F/CMVSS Noncompliance Recall

53501 Tire and Loading Information Label Incorrect

Reference Number: N162053501
GWM Number: 2053501

Release Date: July 2016
Revision: 00

4555806

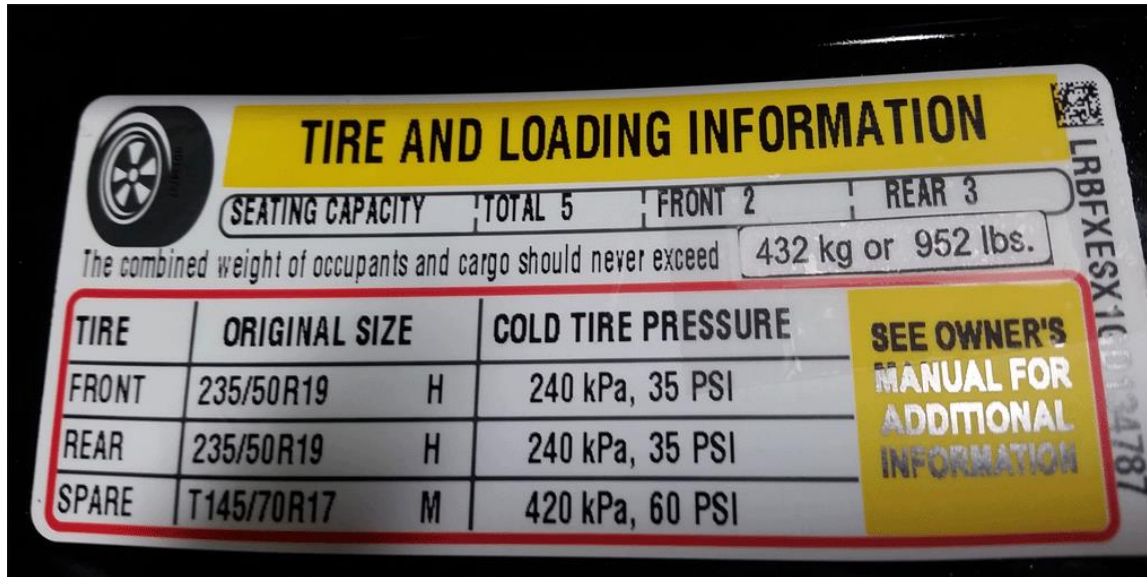
| Condition | General Motors has decided that certain 2016-2017 model year Buick Envision vehicles fail to conform to Federal/Canada Motor Vehicle Safety Standard (FMVSS/CMVSS) No. 110, "Tire Selection and Rims for Motor Vehicles." The maximum combined weight of occupants and cargo for these vehicles may be incorrectly specified on the vehicles' Tire and Loading Information labels. The correct maximum combined weight of occupants and cargo for these vehicles is 432 kg, or 952 lbs. If these vehicles are overloaded, the driver's ability to control the vehicle may be affected in certain conditions, which could increase the risk of a crash. |

2. Locate the tire and loading information label (1).
3. Clean the tire and loading information label with isopropyl alcohol (rubbing alcohol) and a clean shop towel.

| Correction | Dealers will apply overlays to the labels with the correct maximum combined weight of occupants and cargo. |

4. Perform a single strikethrough of the incorrect weight values (1) with a Sharpie Industrial Permanent Ink marker 13601.

5. Install the overlay label over top of the incorrect weight values as shown above. Assure the label is properly positioned before allowing contact with the original label. The overlay label should be installed between the black and red horizontal lines, after the word “exceed”. Do not cover the VIN on the right side of the label.
6. Close the driver door.
7. CALIFORNIA VEHICLES ONLY: Complete a “Proof of Correction” certificate and provide to the vehicle owner upon recall completion.
